**SUBJECT: Project No. R2014-02411-(5)
Minor Conditional Use Permit No. 201400014, Oak Tree Permit No.
201400035, and Environmental Assessment No. 201400194
HO Meeting: April 19, 2016
Agenda Item: 5**

RE: Canyon Crest Conservancy Comment Letter Regarding Project No. R2014 – 02411-(5), ROAK 201400035, and RMCP 201400014.

Re: Independent Arborist Review of Oak Tree Report for APN 5830 003 016 –Canyon Crest Road, Altadena. (REVISED)

Photo from the bottom of the canyon from the adjacent property to the south – downslope of the project.

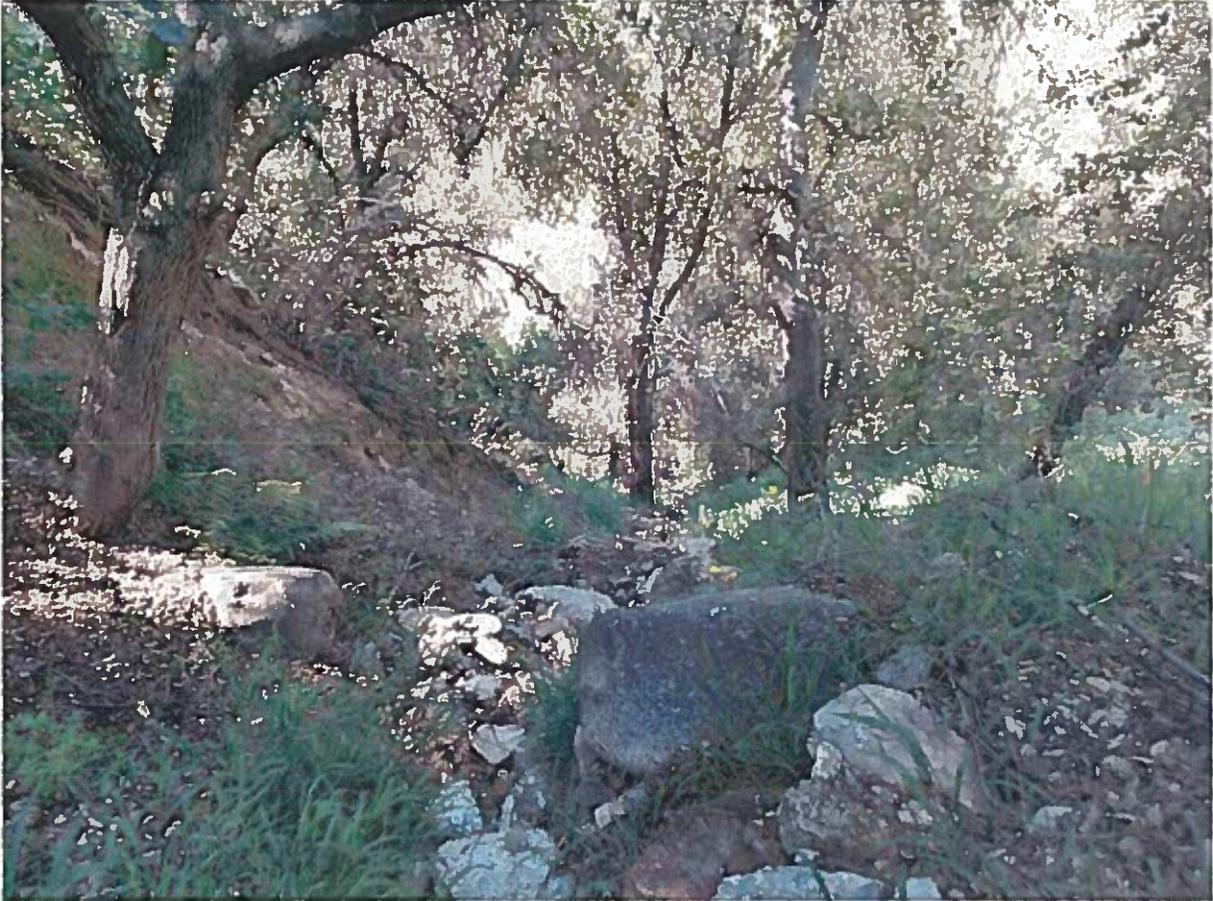
6. The site is located over a significant ecological area. There is a blue-line stream at the bottom of the canyon in the center of the property. This is not addressed in the oak tree report. How will the project prevent sediment and debris from going down the hill? There are multiple oaks and other trees directly below the building site that are not addressed in the oak tree report. They could be directly impacted by a change in hydrology or drainage. Also the slope is full of large boulders that may require removal to construct the proposed pilings.

Large granite boulder that may need to be removed under the building site

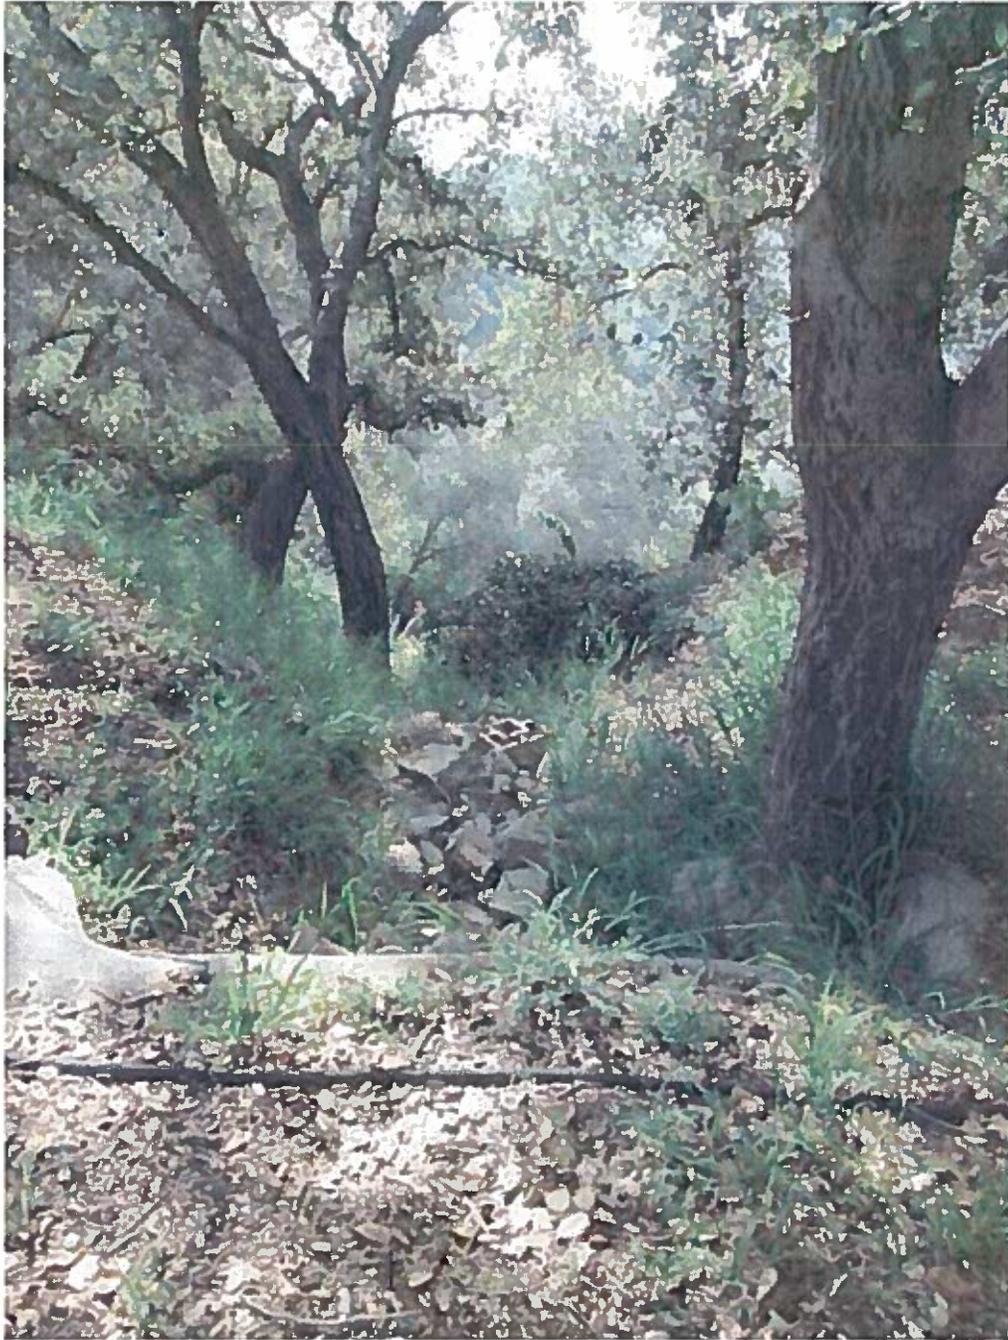
1. Impact analysis for tree #10. The arborist report from LDC says that there will be no impact to tree #10. That is not the case, however, since foundation pilings are within the protected zone and the tree is adjacent to a large boulder that may need to be removed.

Estimated height of structure is over 31 feet and taller than pole
(see 20 foot PVC pipe)

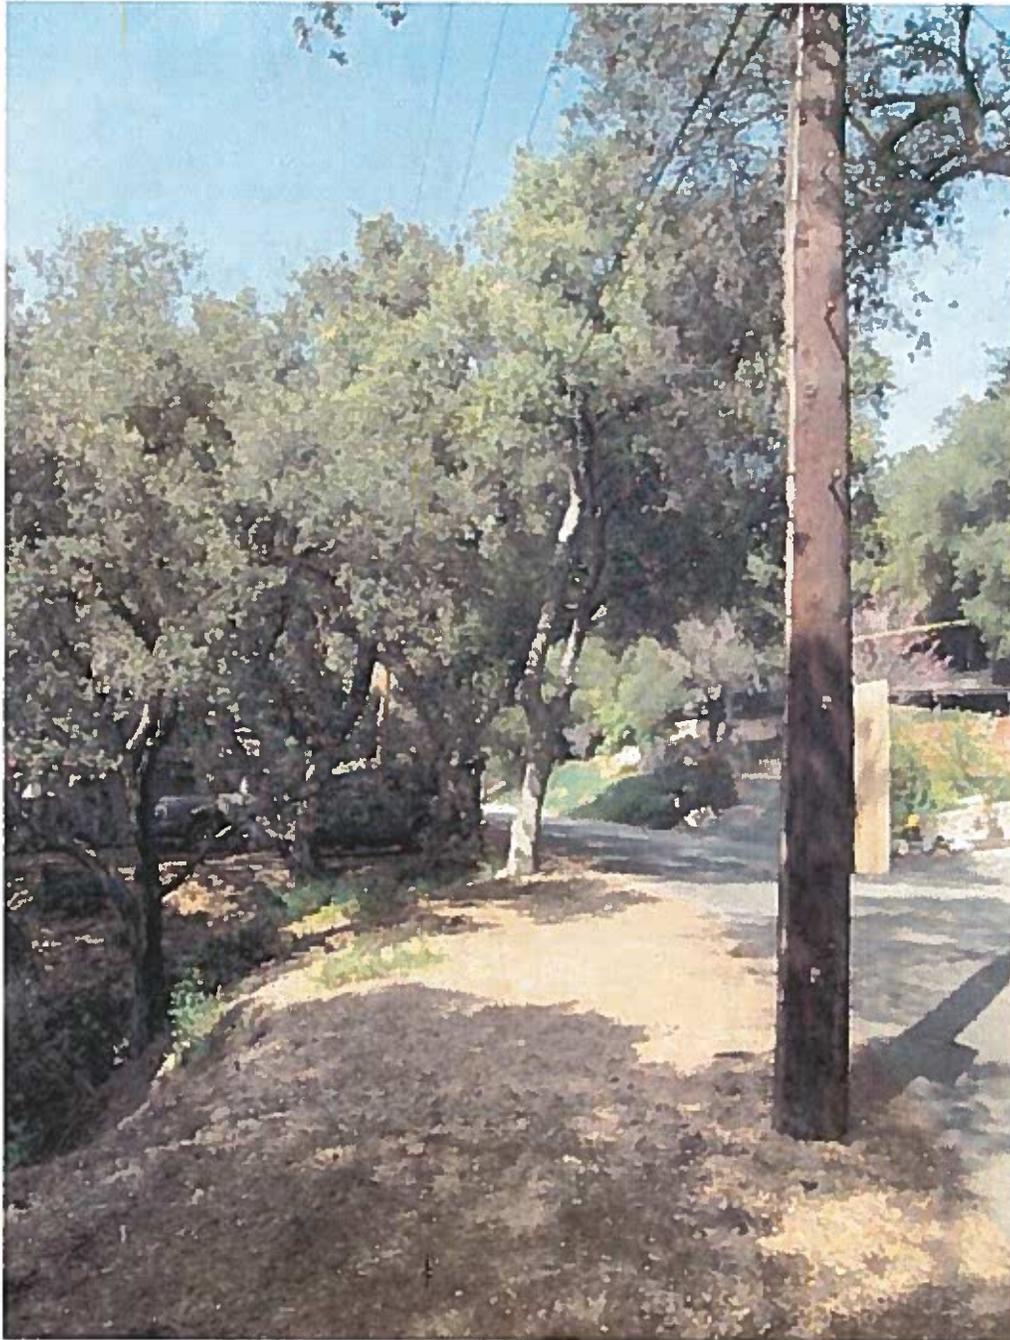
- f. The height of the structure is 31 feet, but the trees are much lower than 33 feet. How does the building fit into the slope under the trees? **I believe that the applicant should be required to put up story poles to demonstrate the actual footprint of the structure and how it interfaces with the trees.**
